ANN ARBOR HISTORIC DISTRICT COMMISSION

Staff Report

ADDRESS: 544 Detroit Street, Application Number HDC14-080

APPLICATION: The applicant seeks HDC approval to increase the size of a previously approved penthouse by an additional 60 square feet and to add a removable metal frame fabric shade structure on the roof.

Roof Plan

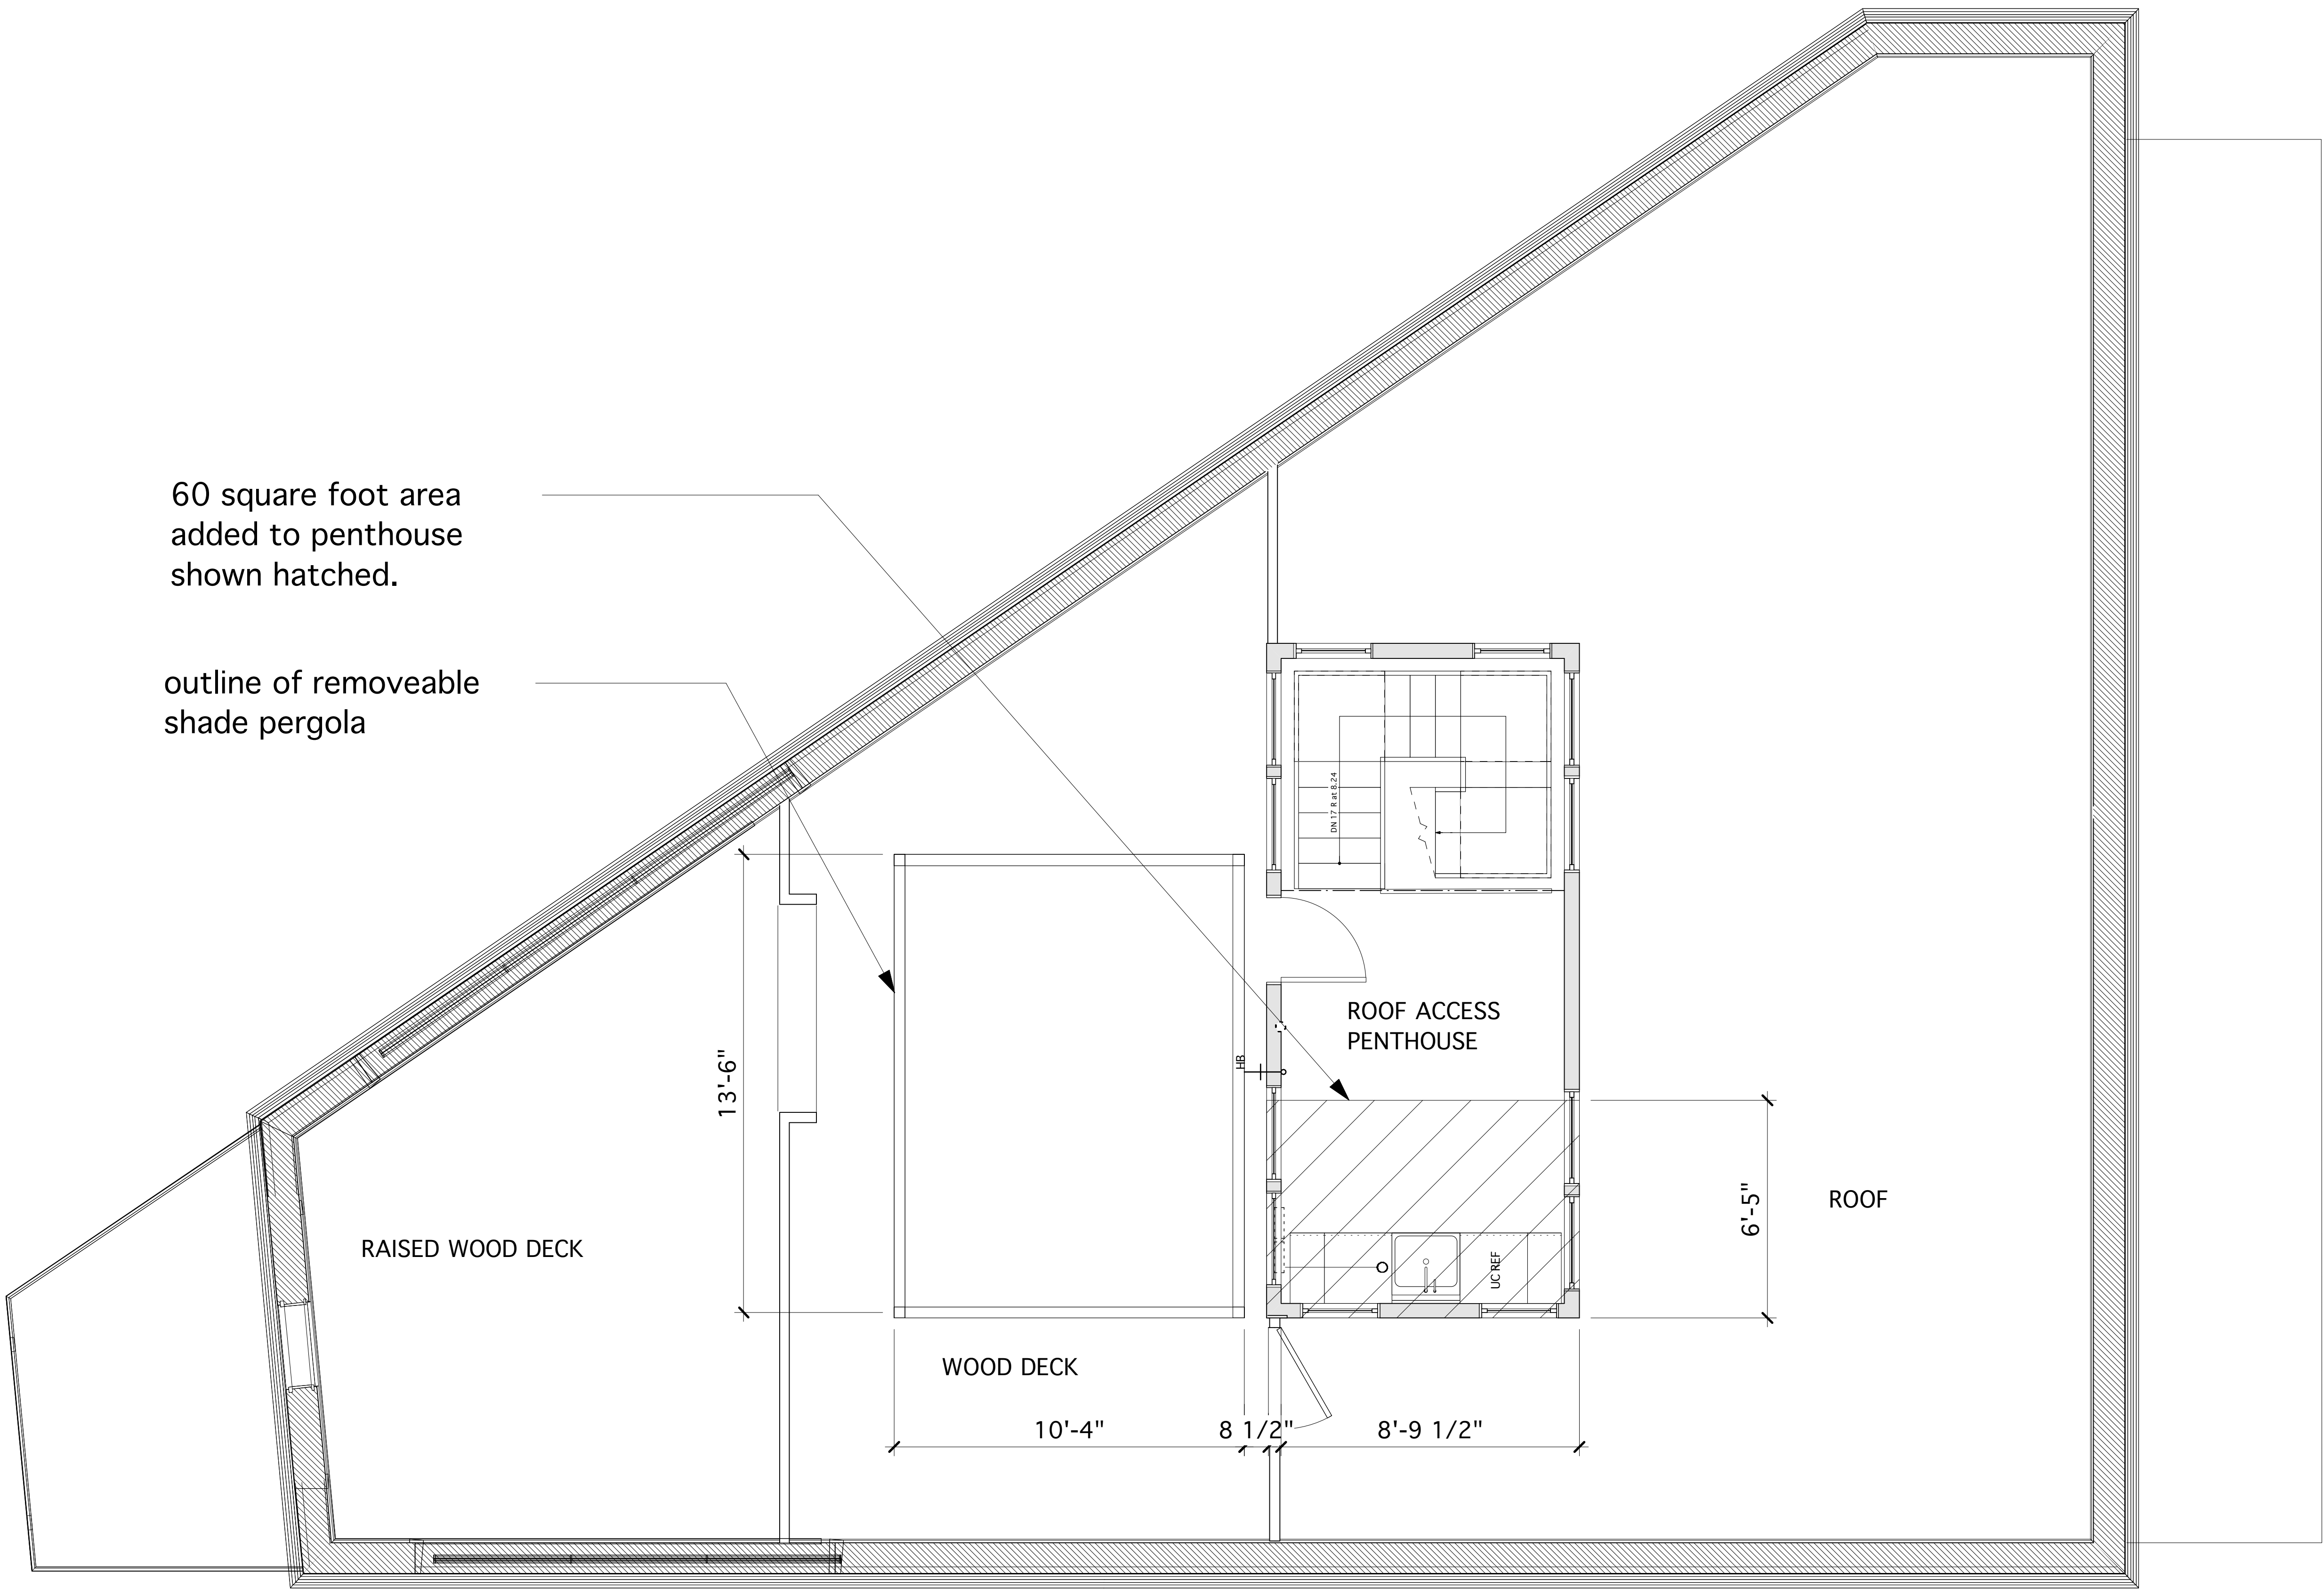
1. Increasing the size of the penthouse will have no negative effects on the previously approved building or the surrounding historic district. The shade structure is removable and only minimally visible from the street and sidewalk. Staff recommends approval of this small modification to the prior plan because it meets the applicable standards and guidelines.

60 square foot area
added to penthouse
shown hatched.

outline of removeable
shade pergola
